PIC32MZ DA Curiosity Development Board Change Notification

Notice 1

Notice 2

Figure 1. Location of Corner Mounting Holes

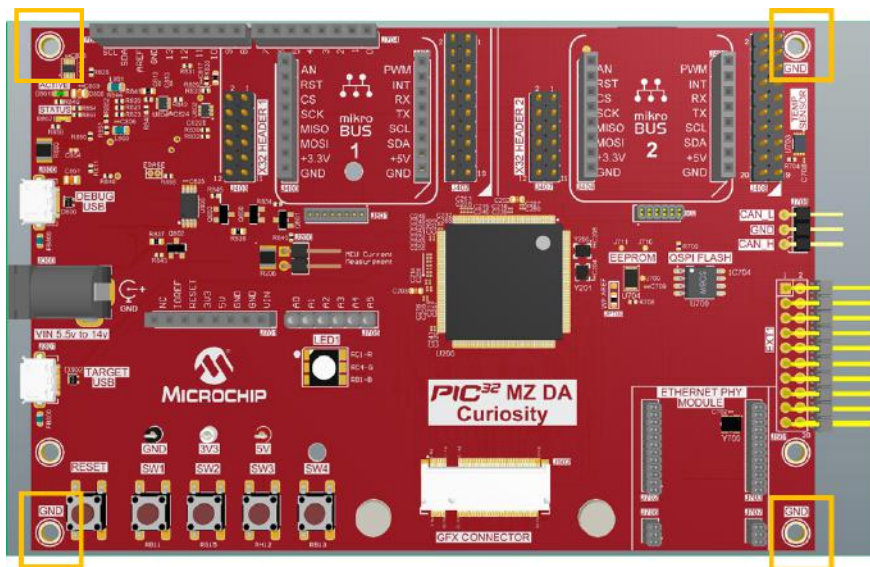
The corner mounting holes labeled 'GND' are not connected to the ground due to an implementation-related issue on the PCB. Therefore, users should not use these holes for the ground connection on the following board:

- The PIC32MZ DA Curiosity Development Board, PCB revision 3.

For a ground connection, use other connectors or pins marked as GND.

The GND mounting holes will be connected to the ground in the board revision 4 and later revisions.

Figure 4. Connecting RF8 to EXT1 PIN15

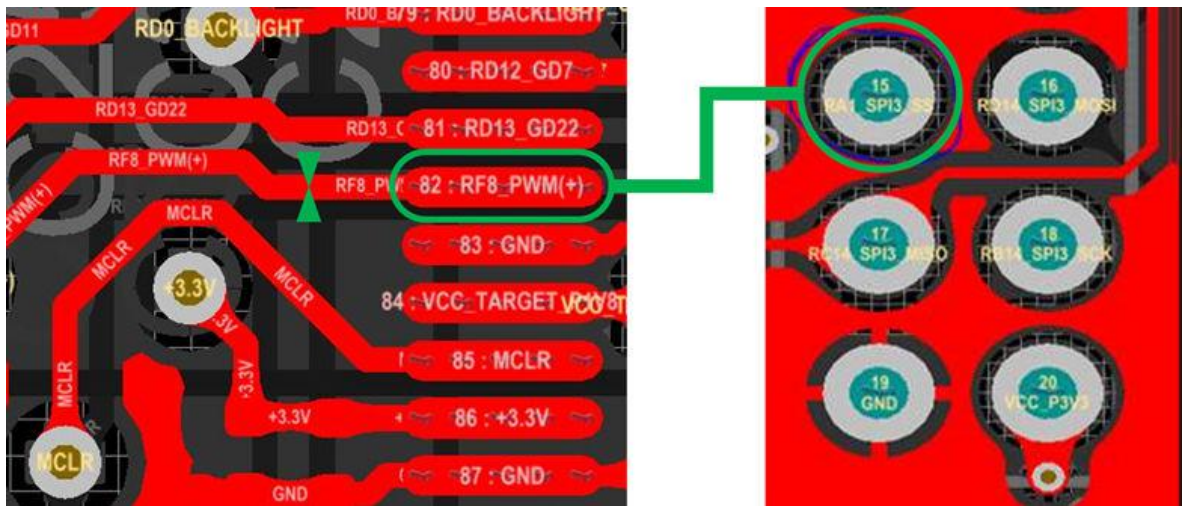
The EXT1 PIN15 (SPI_SS_A) is not connected to the PIC32MZ DA device, therefore this pin cannot be used on the following boards:

- The PIC32MZ DA Curiosity Development Board, PCB revisions 4 and lower.

- Use the pin RF8 for EXT1 PIN15 (SPI_SS_A) and use the pin RA1 for PWM(+).

2. Solder a wire from the U200-pin82 to the EXT1-pin15.
